Comments on Proposed ECO-SPA & Resort in Dingli 26th April 2018

BirdLife Malta reviewed the PDS of the proposed development on PA 5732/17 “Demolition of existing licensed explosives factory & redevelopment into Eco-spa & Resort Class 3A. Development includes excavation of site for accommodation of facilities” and would like to highlight the following points.

Figure 1. Scopolis shearwater distribution in the Maltese Islands (Sultana et al. 2011)

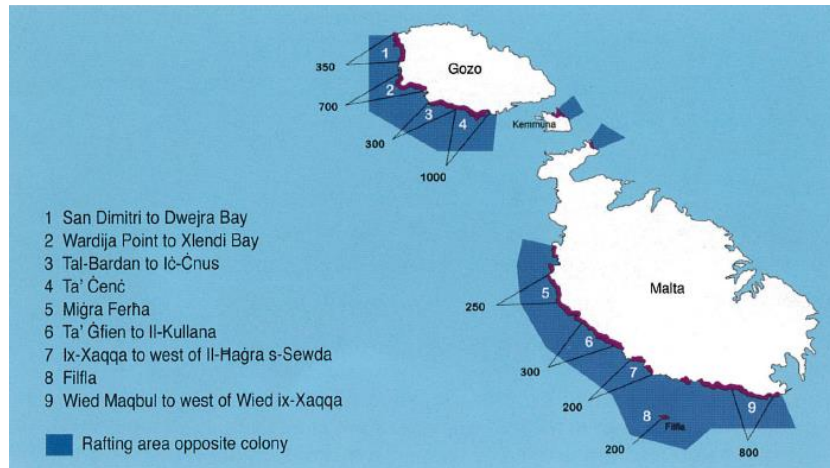
- b. The PDS does not delve into the light pollution aspect it may introduce to the area. While it is assumed that the area does not have much illumination, it is without doubt that both construction and operational phases of the development will cause illumination at night which can overspill to other areas. Accordingly an EIA should look into the exterior and interior lighting and how this will be affecting sensitive receptors such as the sea cliffs (Which are designated as SPAs for seabirds) near and far. Far receptors could include areas such as Ta’ Cenc cliffs and Filfla SPA for which any considerable illumination from this site may be perceived at such distances.
